**AL SHOFA WATER FACILITY  
NASSRIYA, IRAQ**

**SIGIR PA-08-124  
JULY 23, 2008**

SUBJECT: Report on Construction of the Al Shofa Water Facility, Nassriya, Iraq (Report  
Number SIGIR PA-08-124)

## Al Shofa Water Facility, Nassriya, Iraq

Figure 1. Al Shofa Plan (Courtesy of the USACE)

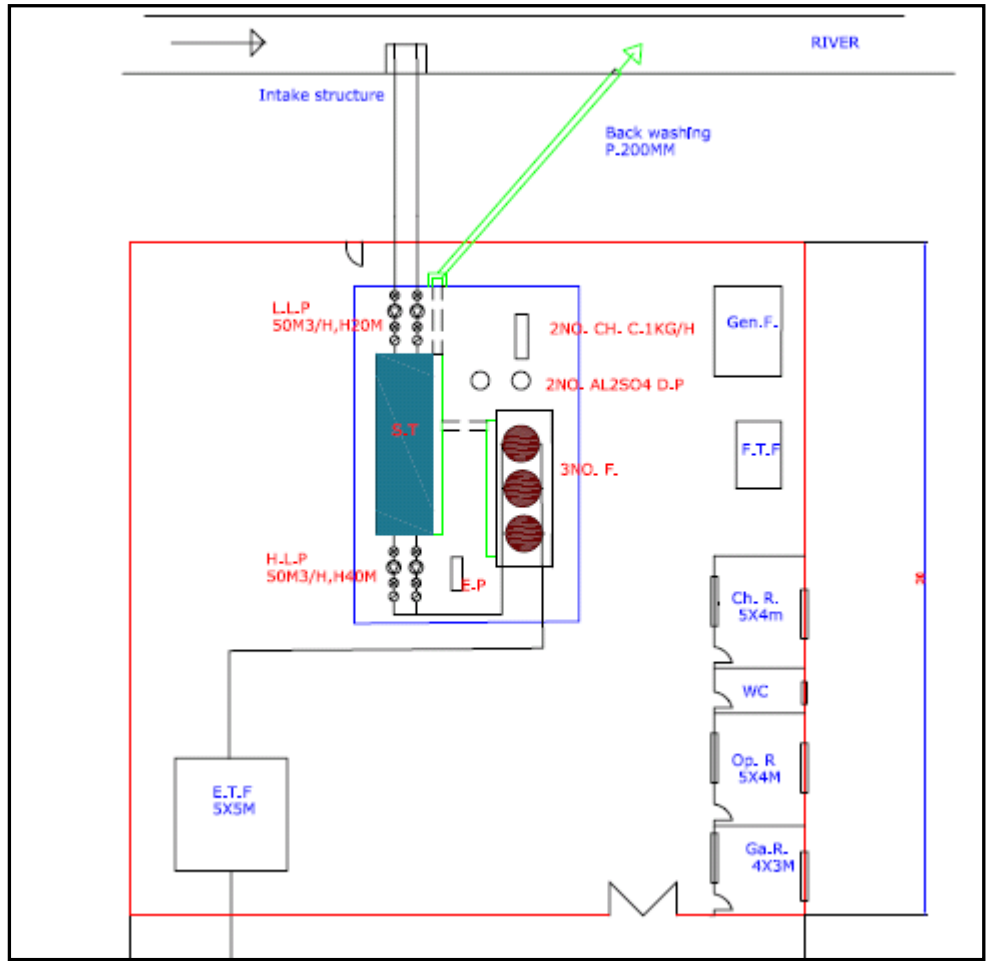
The USACE provided SIGIR with copies of the contractor's Al Shofa Water Facility project designs and specifications. The designs included the site layout (Figure 1), which provided the water compact unit layout and the building sizes. Also included in the contractor's design was the wall section design, which showed the expansion joint (Figure 2) and the cross-section of the wall (Figure 3).

After reviewing all available design drawings and specifications, SIGIR determined the design package was not complete and lacked sufficient details. Specifically, the designs did not provide any system overview detailing the process of raw river water entering the clarifier, being converted to drinking water, and then released to the end point (supply). In addition, the designs lacked necessary details, such as the sizes of pipes used, the potential need for pipe reducers, diameters for air and outlet nozzles for the high pressure filters, equipment lists, and diagram scales.

Further, the design package lacked architectural, civil, electrical, mechanical, and structural drawings for the chemical and operator buildings, and a foundation plan and conceptual layout of the elevated storage reservoir.

Figure 3. Al Shofa design layout (Courtesy of the USACE)

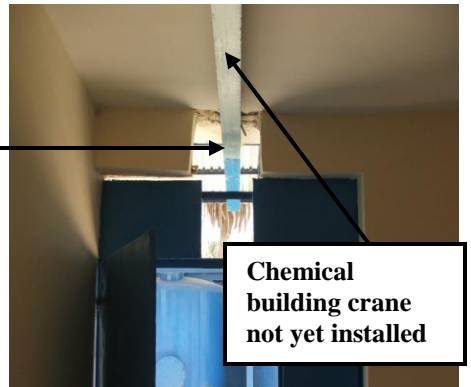
The contractor's site plan layout (Figure 4) included the following: elevated water tank, chemical building (Site Photo 10), water compact unit, operator building, light poles, and individual sunshades for the water compact unit, generator, and fuel tank.

At the time of our second site visit, the contractor had not completed the chemical and operator buildings, water compact unit, light poles, and the sunshade for the water compact unit. For example, electrical work was still required in both the chemical and operator buildings (Site Photo 9). In addition, the contractor had not installed the crane for the chemical building (Site Photo 11). The water compact unit sunshade and individual pieces of equipment still need to be bolted into the concrete slab (Site Photos 12 to 14).
